**NOTICE OF A REGULAR MEETING
BONDURANT PLANNING AND ZONING COMMISSION
JANUARY 12, 2023**

TITLE: - RESOLUTION NO. PZ-230112-03 considering recommended approval of the Hawthorne Crossing 2 Site Plan/Preliminary Plat

THE CROSSING

BUILDING #2 ELEVATIONS

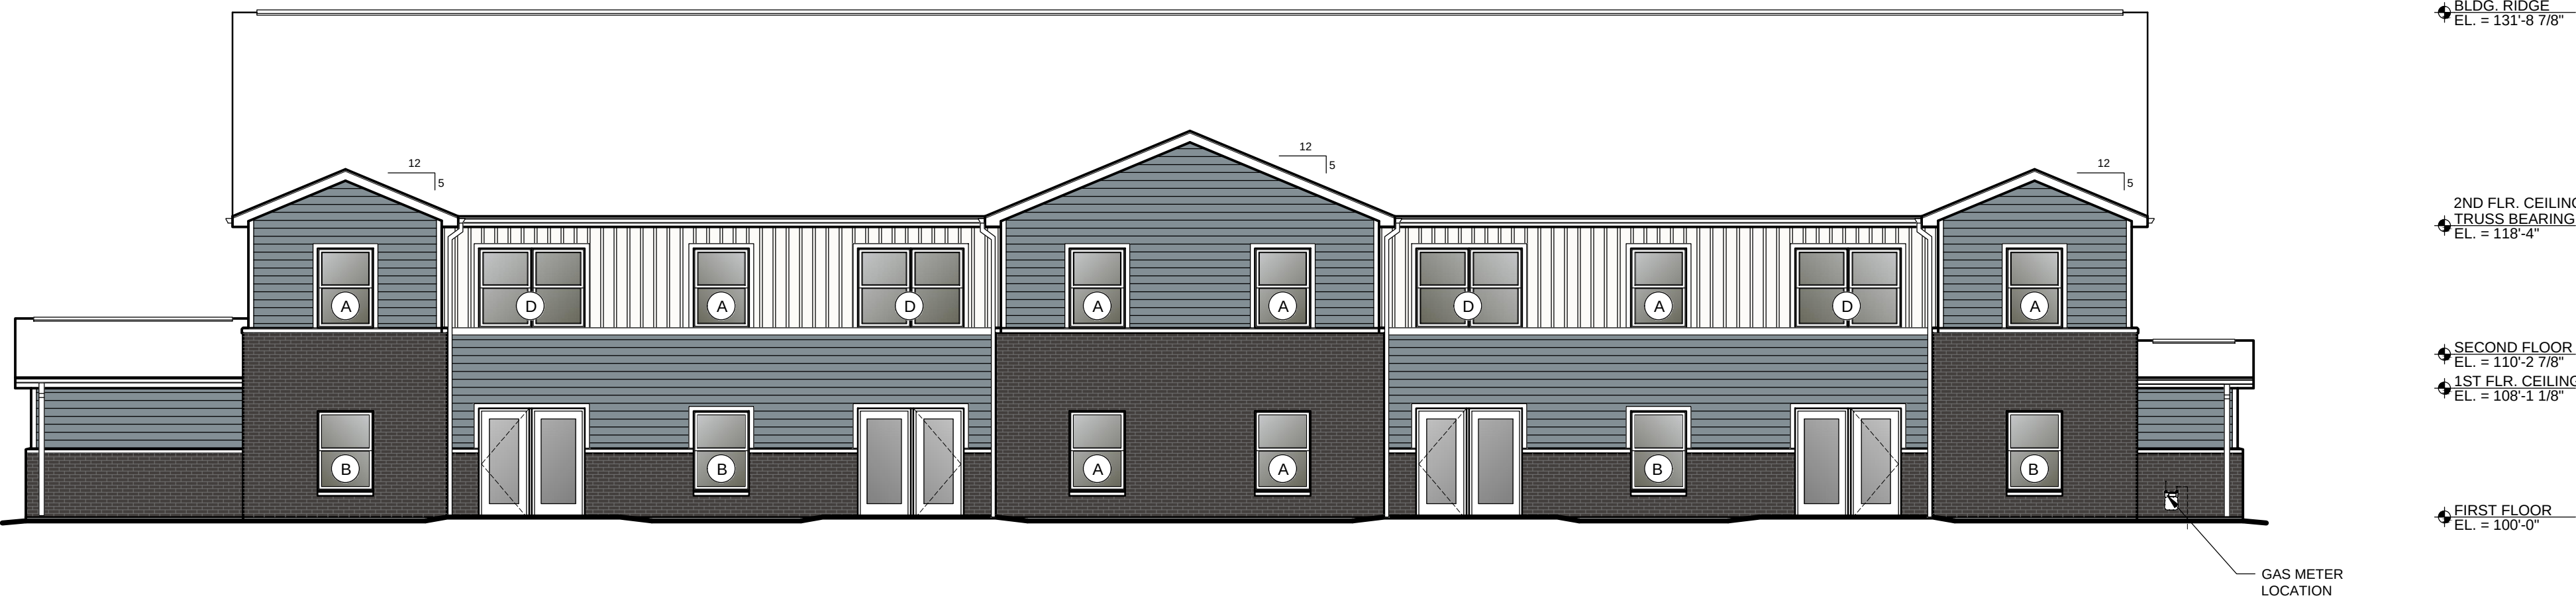
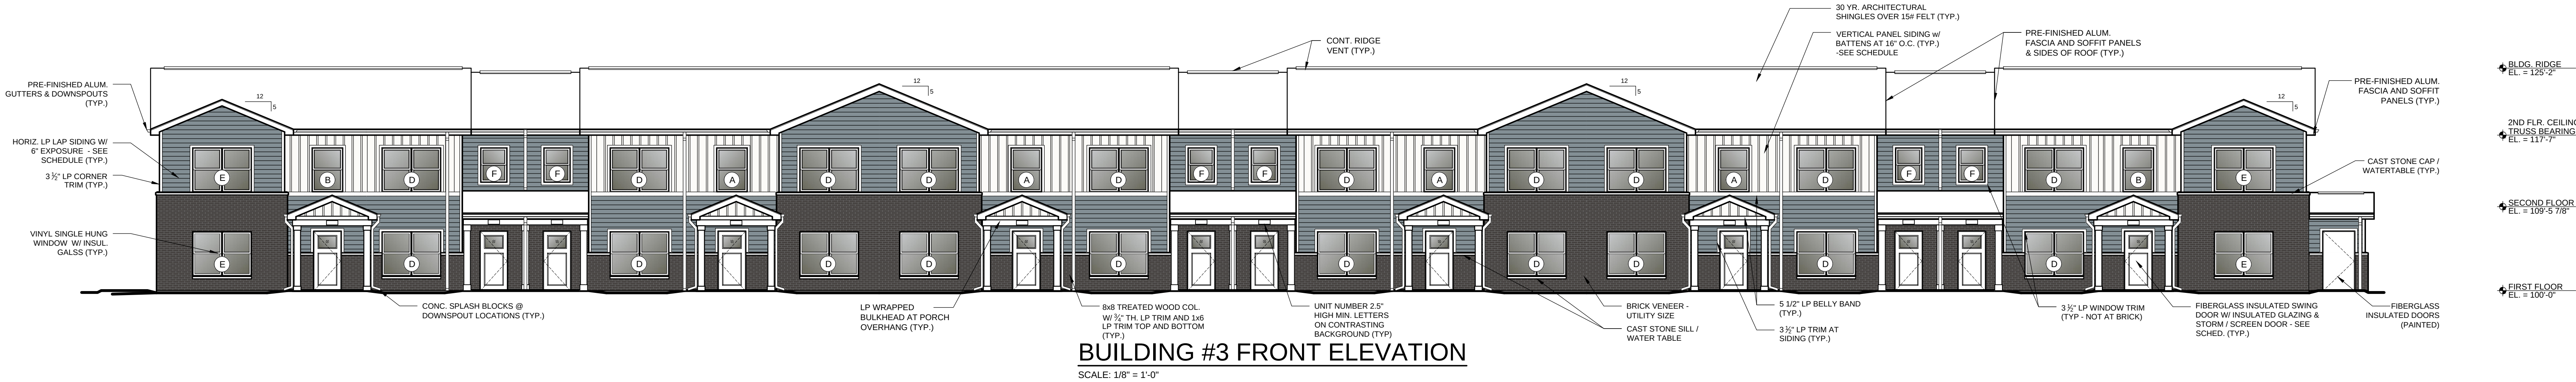
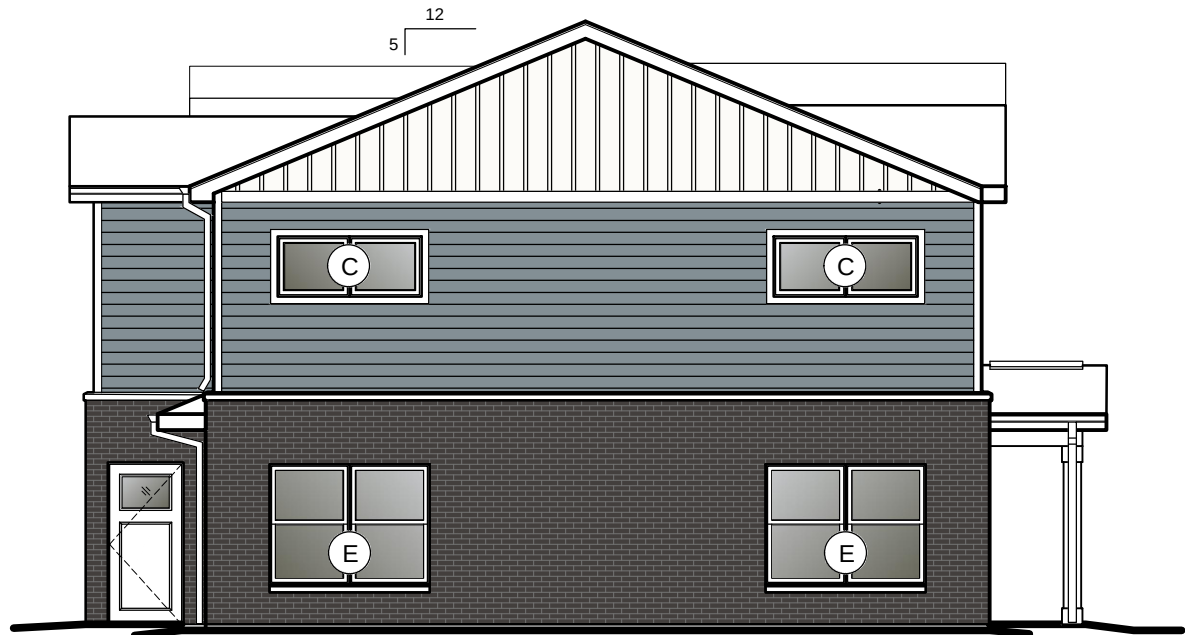
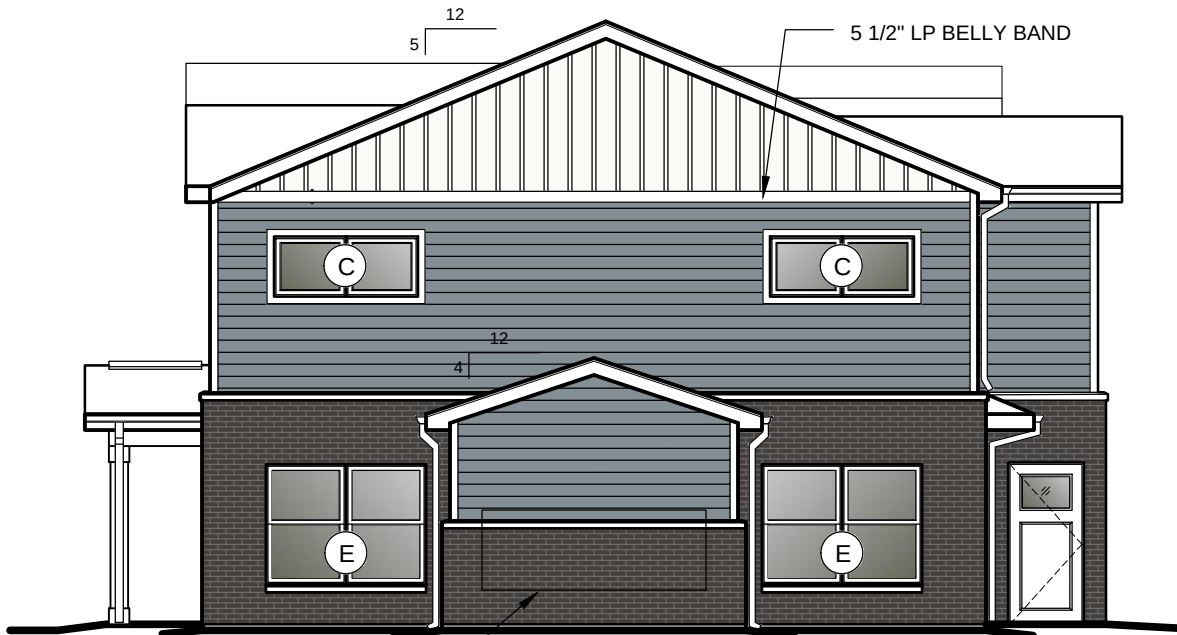
- Building Materials:
 - Hard Surface Requirements
 - At least 20% of multi-family structures shall be brick, stone, or a similar substantial material. This requirement applies to both those facades that face the public right-of-way and those facades that do not face the public right-of-way which are not screened. If a non-street facing façade is screened, the primary materials must be present as at least trim. Door and window openings can count toward this 20% requirement if surrounded by brick, stone, or another substantial material. *Page 1 of the elevations sheet shows brick veneer being utilized. Appears to be meeting just fine, but elevations to be updated to provide a brick/stone calculation requirement for each building façade elevation of each building.*

- At least every fifty linear feet (50'), wall and roof planes shall contain offsets or setbacks with a differential in horizontal plane of at least two feet (2'). *Site plan applicant to confirm this is being met for all elevations.*

1 MONUMENT SIGN ELEVATION
A3.6 SCALE: 1/2" = 1'-0"

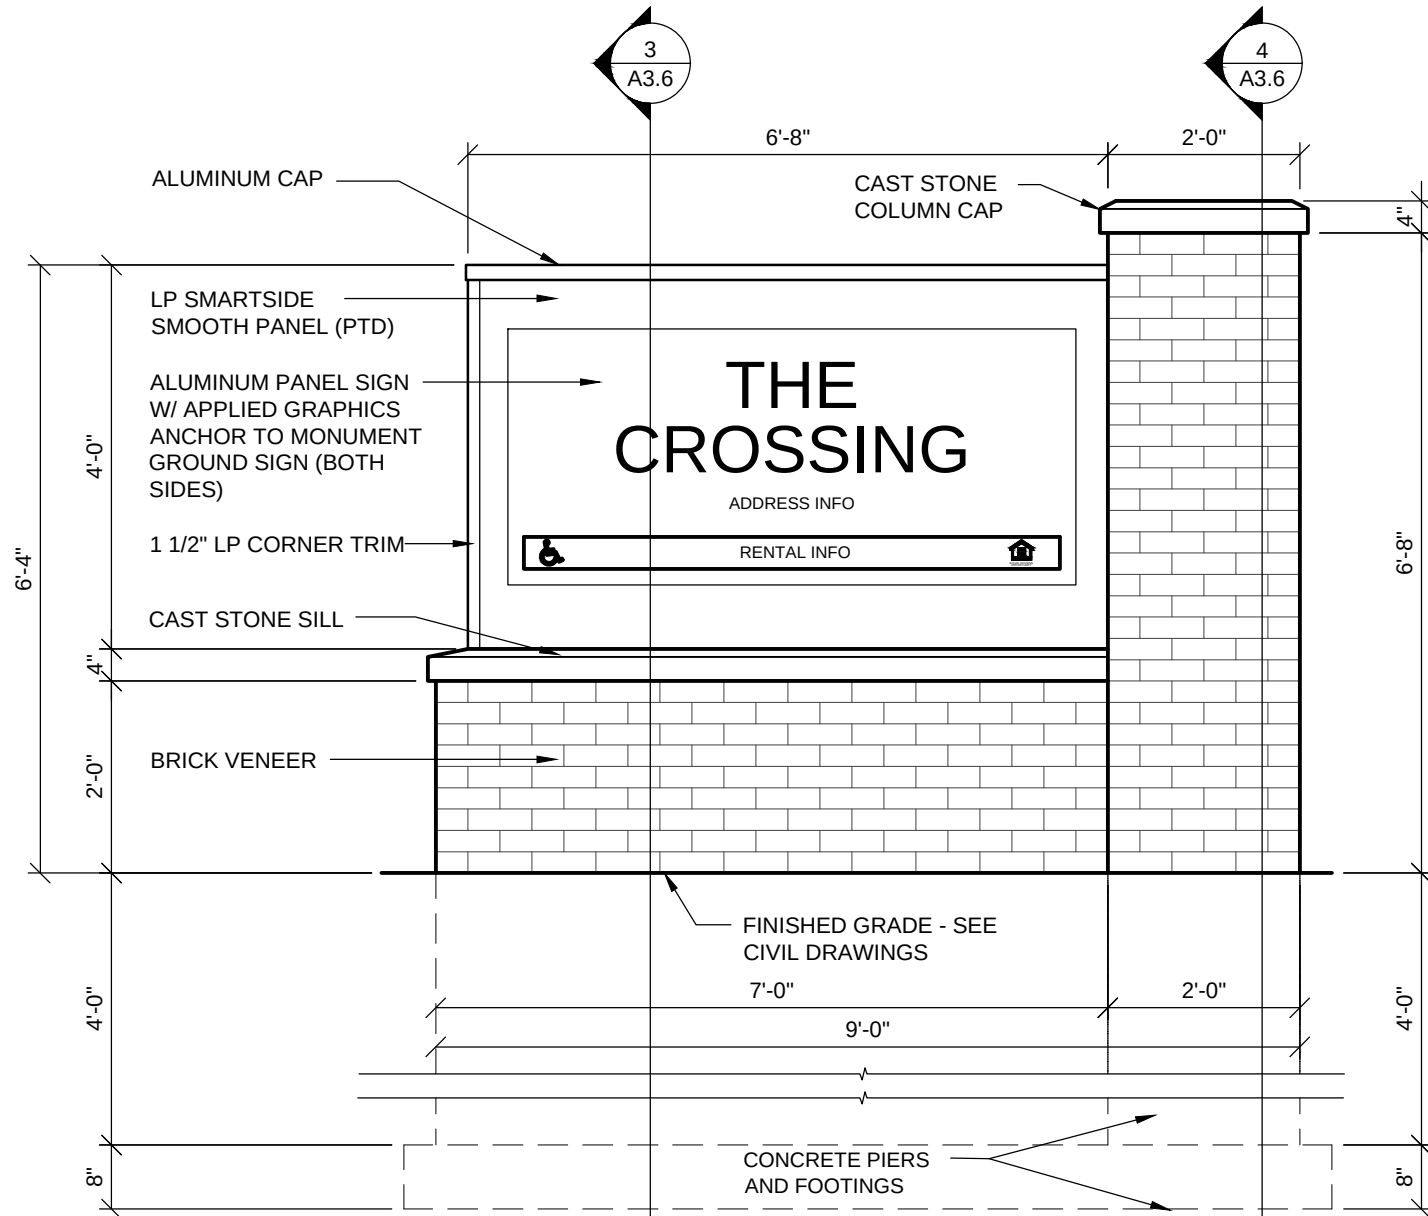
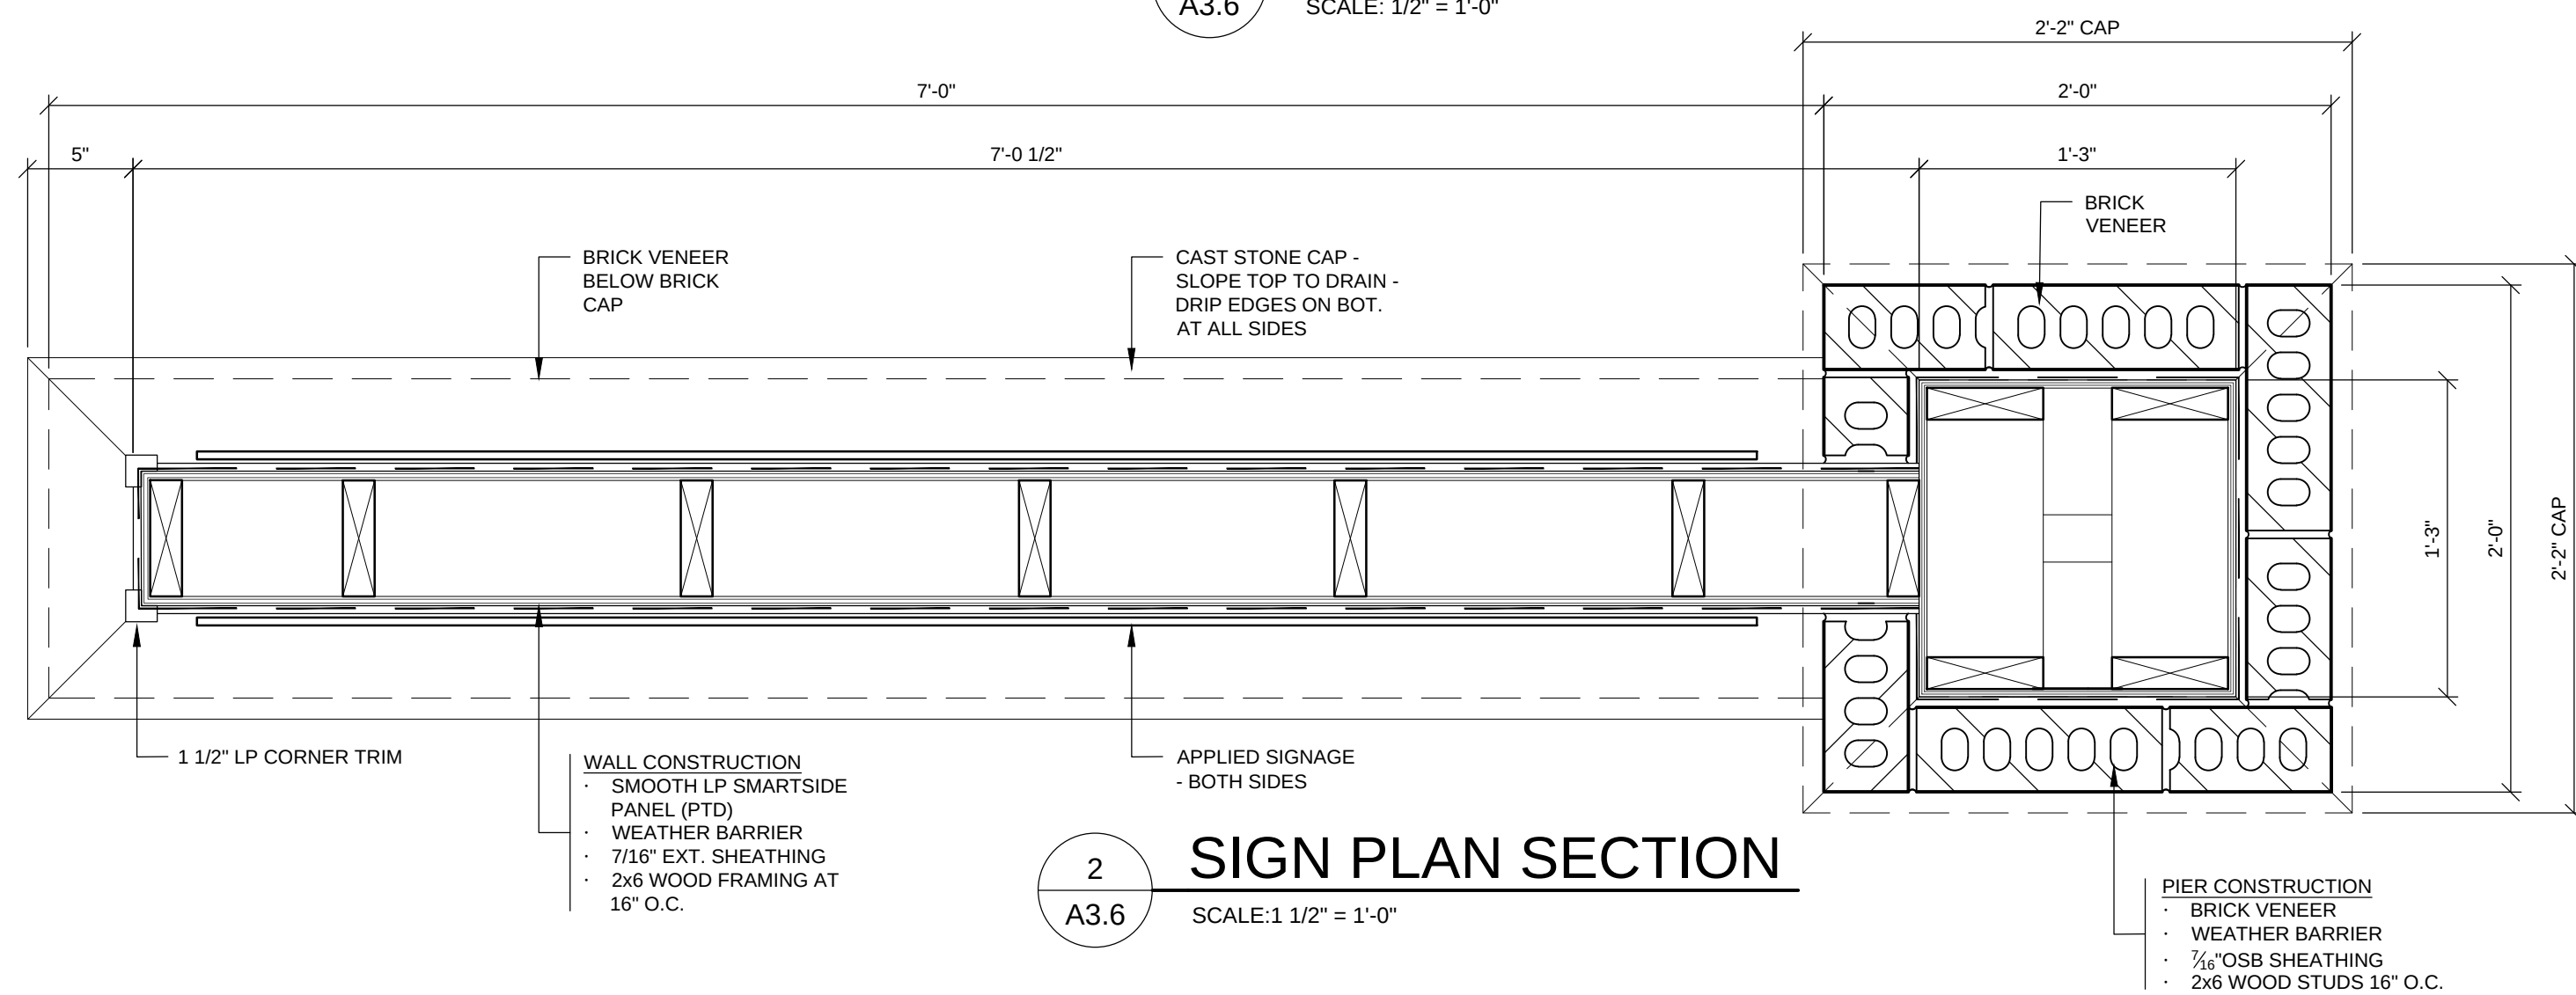
- A note that while sign permits are reviewed and approved administratively and separately from site plan approval, the site plan must show any detached signage proposed. The site plan shows a detached sign along Courtyard Drive SE. A sign contractor must receive an approved sign permit prior to signage installation. All signage proposed must meet Section 181.12 of the Sign Code.
